Docket # 2023 NOV

RE: PacifiCorp's Response to Notice of Violation – NOV_CAD_PC_SIS_20240509_0914

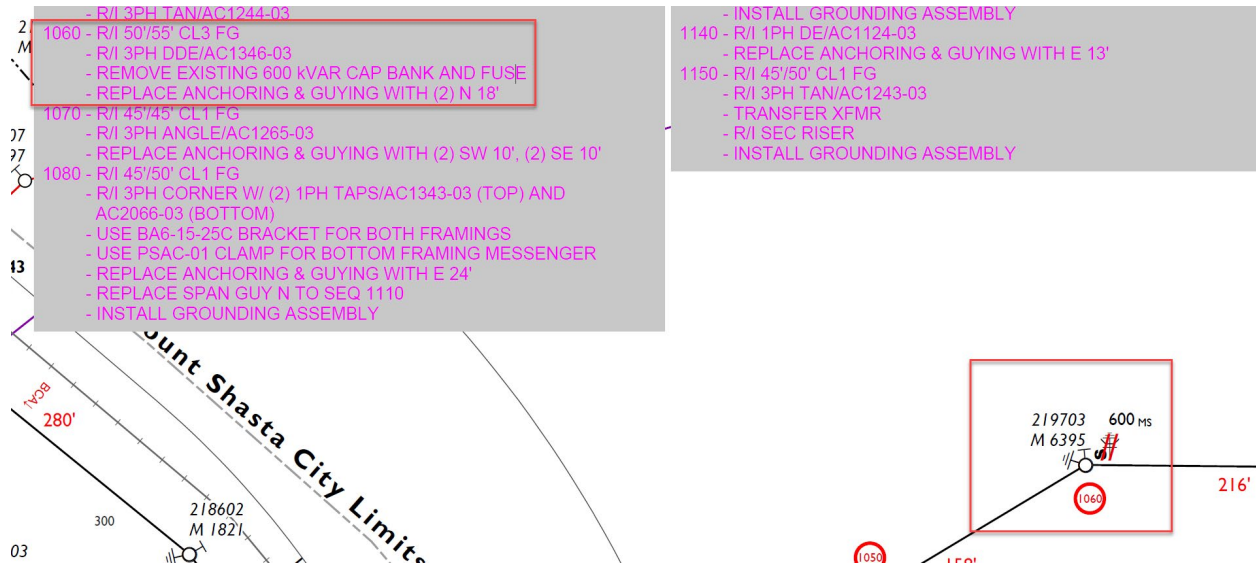
Violation 1. Energy Safety observed that in implementing 2023 WMP initiative 8.1.2.12 - Expulsion Fuse Replacements, PacifiCorp failed to provide accurate data in reporting that expulsion fuses were replaced on pole ID 06240004.0219703 at coordinates 41.3009857032377, -122.307145186836. Energy Safety considers this data accuracy violation to be in the Minor risk category.

In response to the notice of violation, the company conducted a field inspection on June 26, 2024. PacifiCorp provided an inaccurate Structure ID, PacifiCorp crews removed the capacitor bank and fuse, which aligns with the engineered design.

See the screenshot below from the engineered design.
